HERITAGE VAUGHAN COMMITTEE JUNE 19, 2013

1. 1 CLADDAMOUR PLACE – PROPOSED NEW CONSTRUCTION – WARD 2

1 CLADDAMOUR PLACE CHANGES

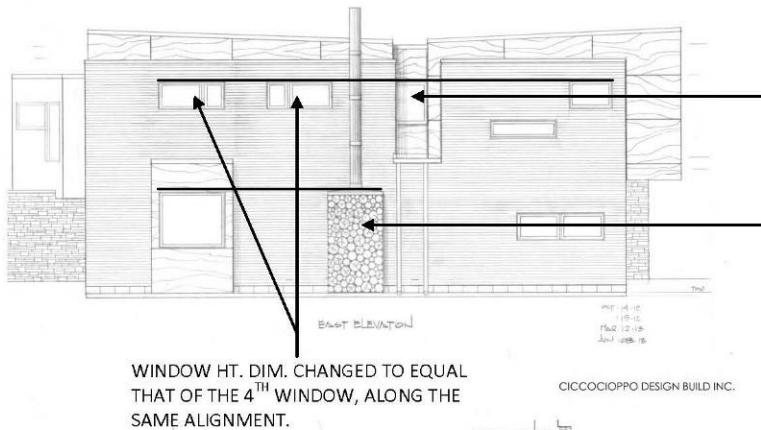
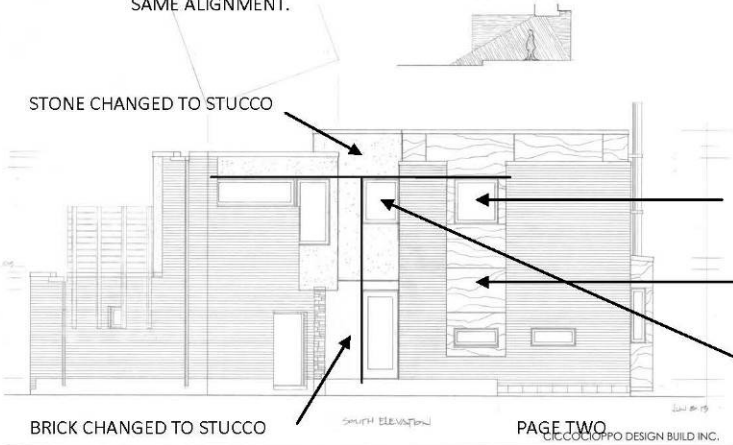
WINDOW HT. DIM. CHANGED

SILL PANELS ARE TILTED BACK TO
SIMULATE LARGER WINDOWS

BRICK CHANGED TO STUCCO

WINDOW HT. DIM. CHANGED AND
ALIGNED W/ ADJACENT WINDOWS
AND WOOD PANEL DIM.

ALL GLASS DOOR CHANGED TO
PAINTED WOOD DOOR. SEE PG.6

WINDOW HT. DIM. CHANGED TO MEET UNDERSIDE
OF CANTILEVER.

WINDOW HT. CHANGED TO ALIGN
HORIZONTALLY.

LOG PROJECTION ALIGNED
HORIZONTALLY W/ PROJECTION
WINDOW.

WINDOW HT. DIM. CHANGED TO EQUAL
THAT OF THE 4TH WINDOW, ALONG THE
SAME ALIGNMENT.

WINDOW HT. DIM. CHANGED TO
ALIGN HORIZONTALLY.

WOOD PANEL PROJECTION WEDGE
DELETED TO MEET FLUSH W/ UPPER
PANEL.

WINDOW HT./WIDTH DIM. CHANGED
TO ALIGN BOTH HORIZONTALLY AND
VERTICALLY.
